Plan Commission

Monday, November 23, 2020

SUBJECT: Consideration and possible action on a request for a site plan to add 4,000 SF to an existing building at 650 Heritage RD (Parcel ED-F0097).

SUBJECT: Consideration and possible action on a request for a site plan for a 77,436 SF new building with 120 stalls of parking at 221 S Broadway ST, 135 S Wisconsin ST and part of 200 BLK S Michigan ST (Parcels ED-812, ED-914, part of ED-920).

Proposed building addition:

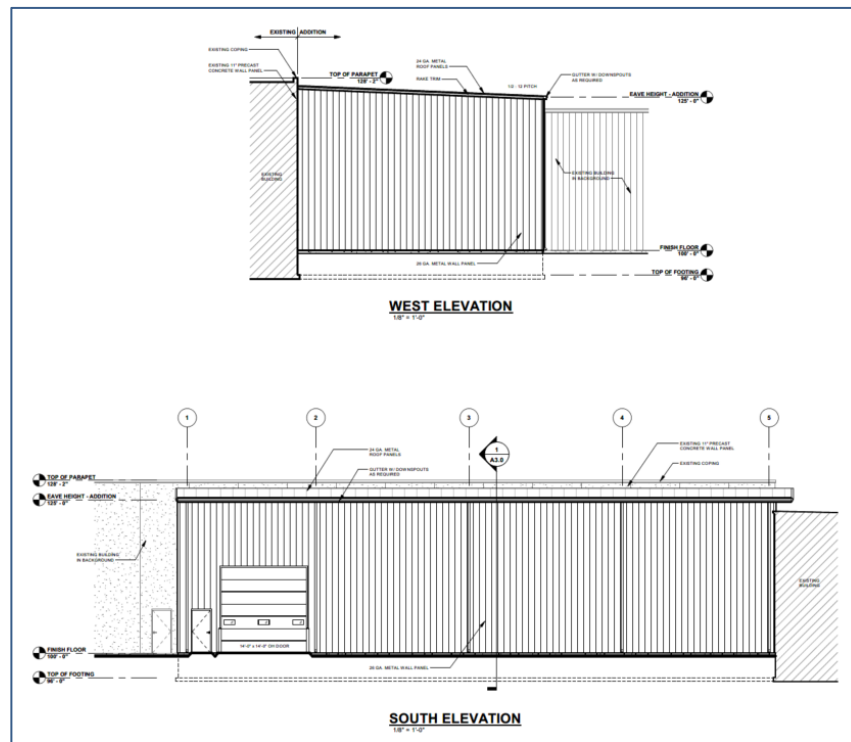
- The use of metal on the side and rear may be considered on the I-3 District zoned property if approved by Plan Commission.

There are no new driveways, parking lots, or loading docks proposed to accommodate the expansion as it will be accessed from the existing pavement. The expansion does not increase the number of employees; however, the number of required parking stalls needs to be identified on the site plan.

1. Use of metal may be acceptable on the side façade, only if approved by Plan Commission.

The Plan Commission recommendation should include a reference to approval (or non-approval) of the use of metal on the building addition.

CONCEPTUAL SITE PLAN

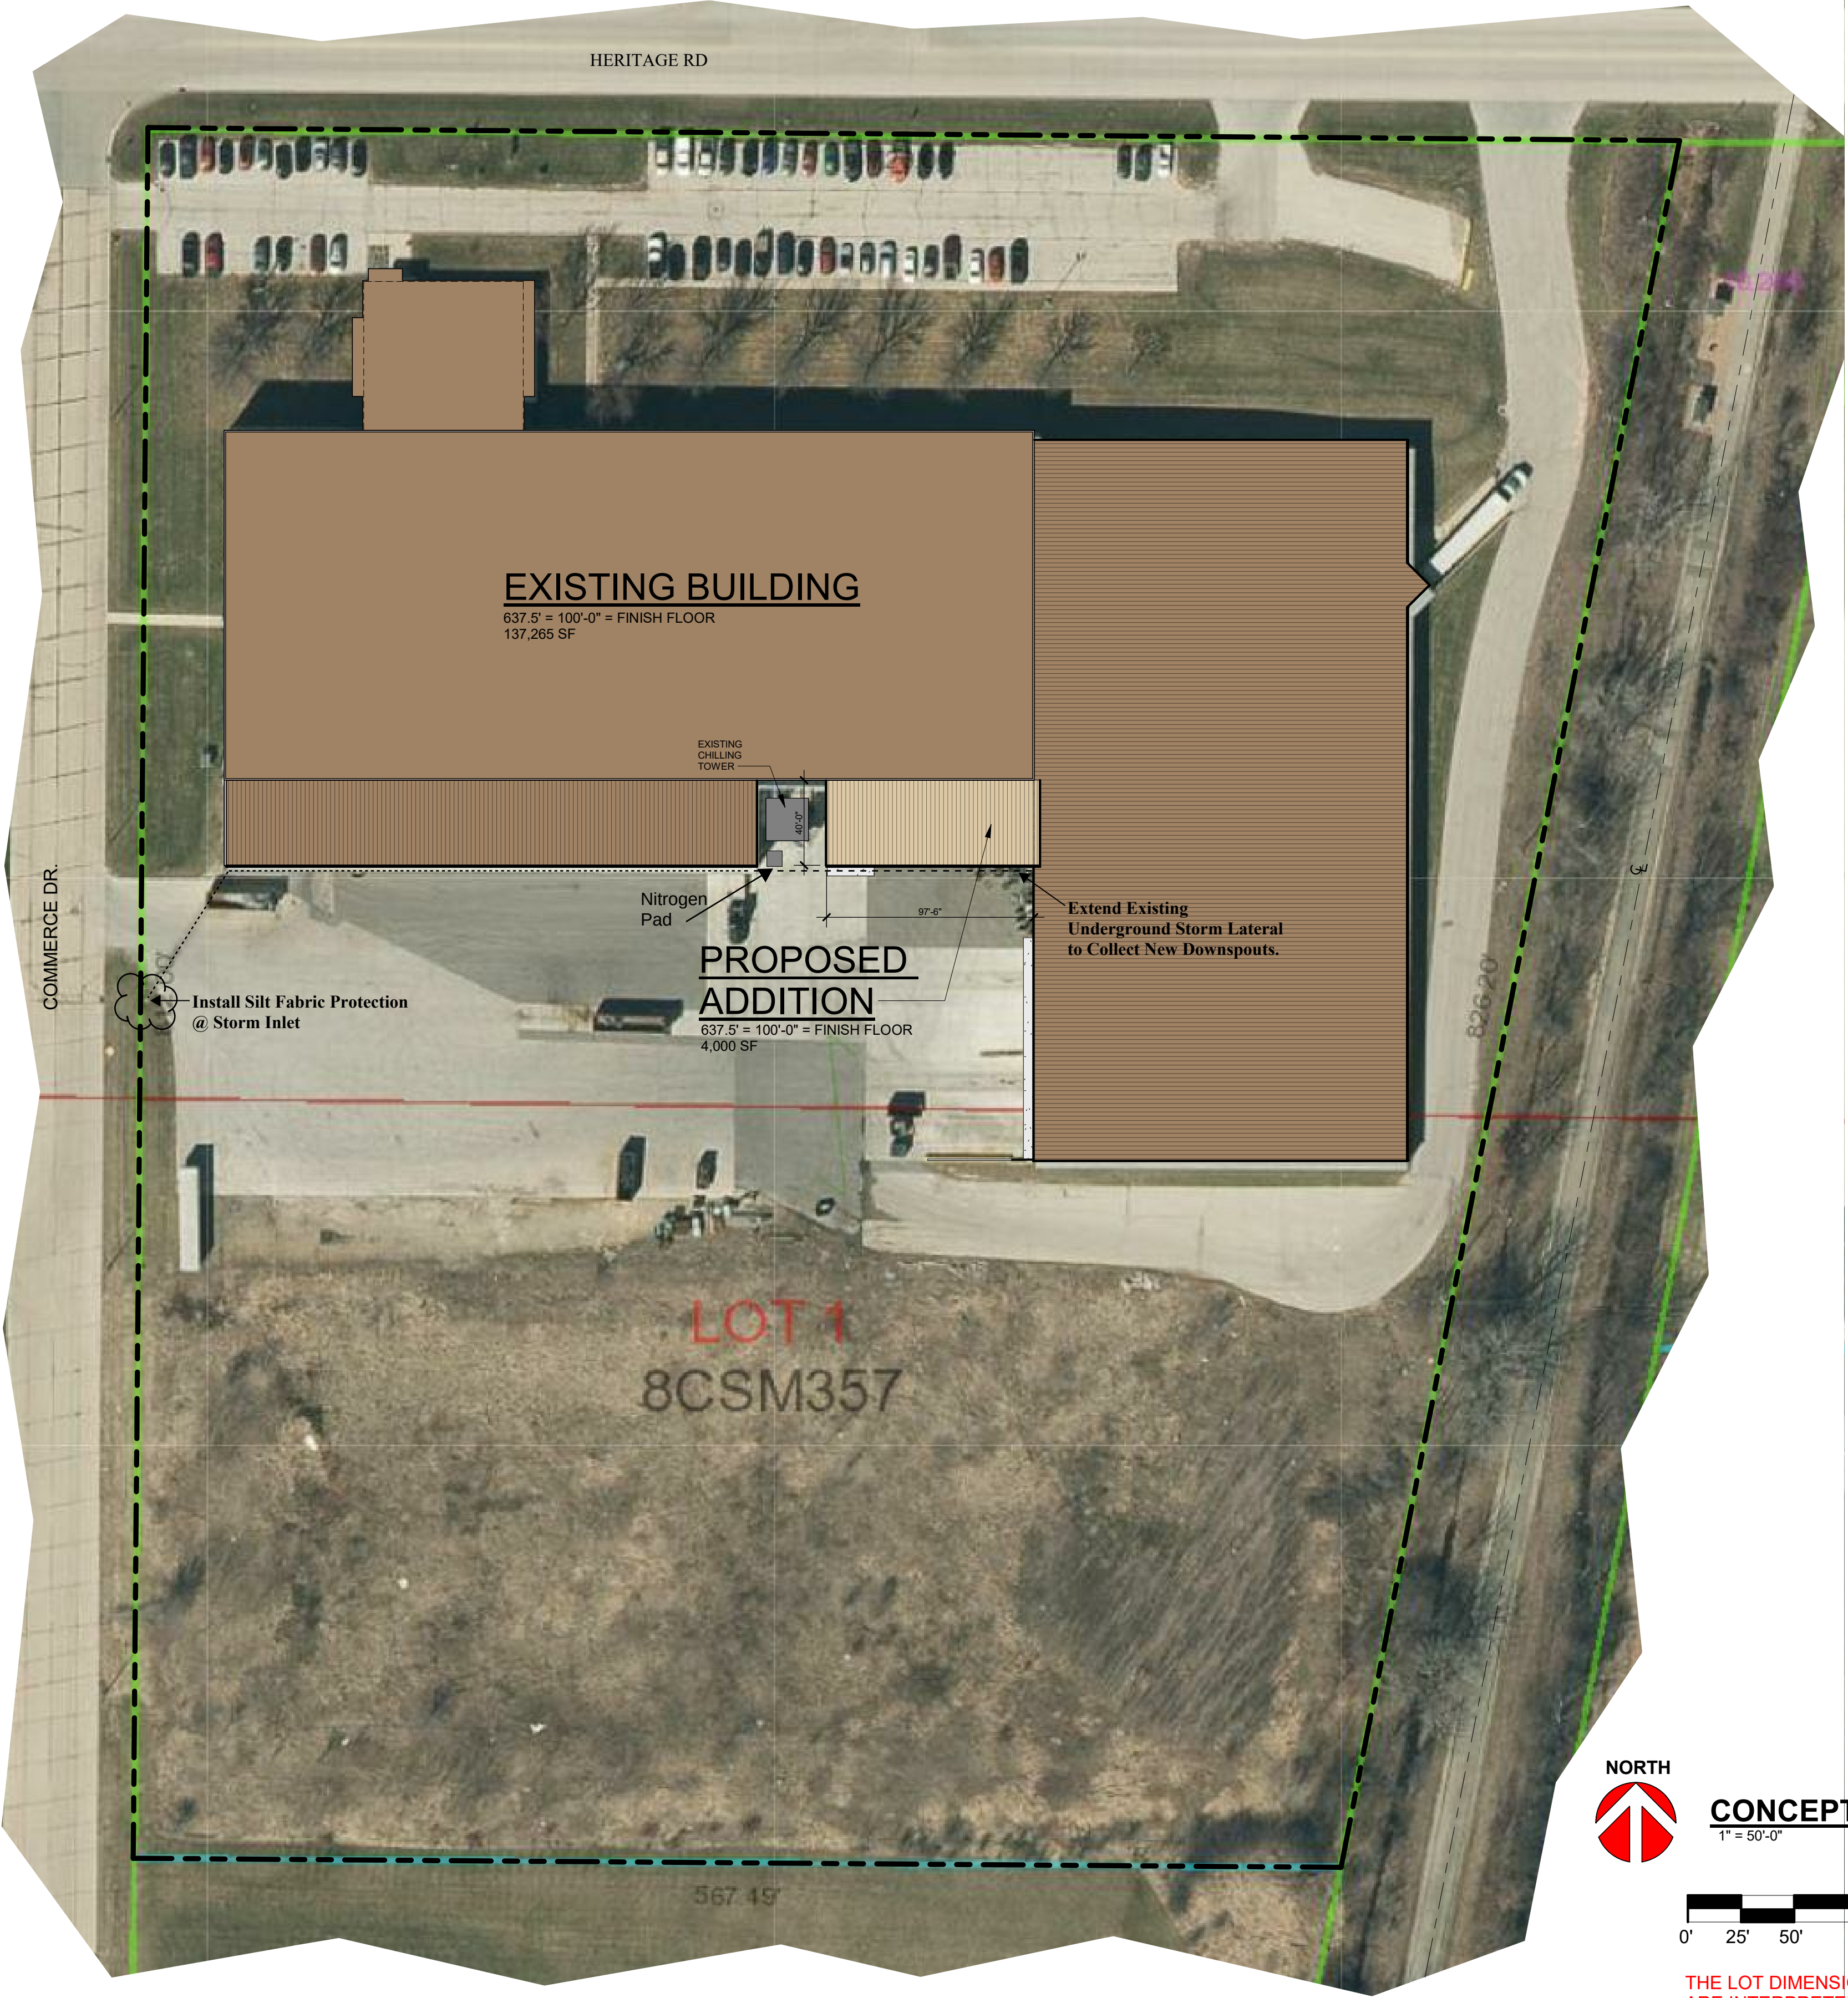
- Confirm there is no planned utility work for this building expansion. No Electrical, Gas or Sanitary work is planned for this project. Building downspouts will connect into existing underground stormwater piping.
- Provide erosion control plans. Inlet protection will be install in the existing stormwater basin.
- Facades are a 26 ga. metal wall panel - fasteners must be concealed or semi-concealed and colored to match. Use of metal may be acceptable on side façade, only if approved by Plan Commission. South and West exterior facades are 26 gauge architectural metal wall panels with semi-concealed color match fasteners.

Building façade elevations:

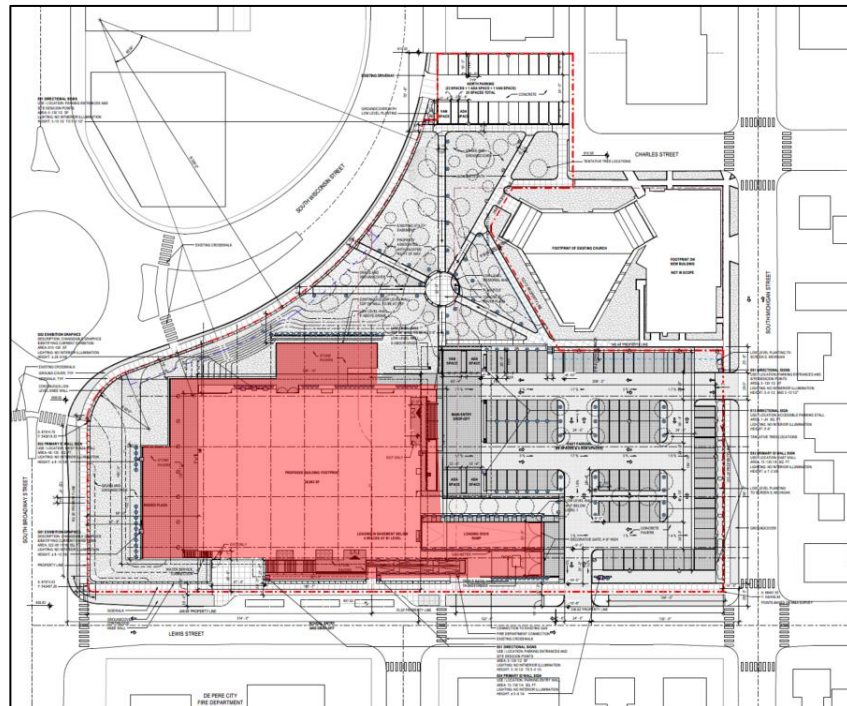
The proposed building is white/grey in color. The proposed side façade materials on all four sides of the building are identified as glass and limestone, which are permitted façade materials. The trim on the edge of the roofline is aluminum, which is permitted when used as trim.

5. Sheet ASK-072B and elevations: The plans show 131 signs. Plan Commission reviews concept sign locations as part of the site plan and any variances as part of the sign variance. Separate sign permit(s) is required through the City Inspection Division.

Rendering of proposed wall sign facing north (S Wisconsin ST).

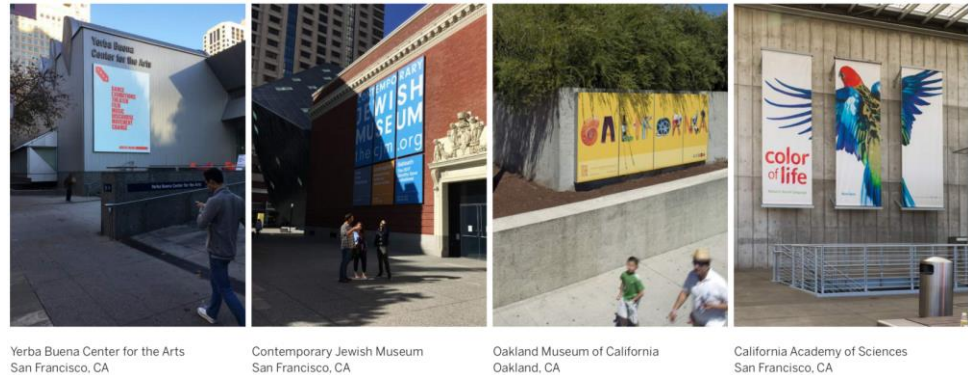
1. Sign Facing North (S Wisconsin ST).
 - a. Sign square footage of ~642 SF, exceeding 50 SF.
 - b. Sign height of ~29', exceeding 20' high.
2. Sign facing west (Broadway ST).
 - a. Sign square footage of ~349 SF, exceeding 50 SF.
 - b. The fifth sign, exceeding the maximum number of four signs on the entire site.
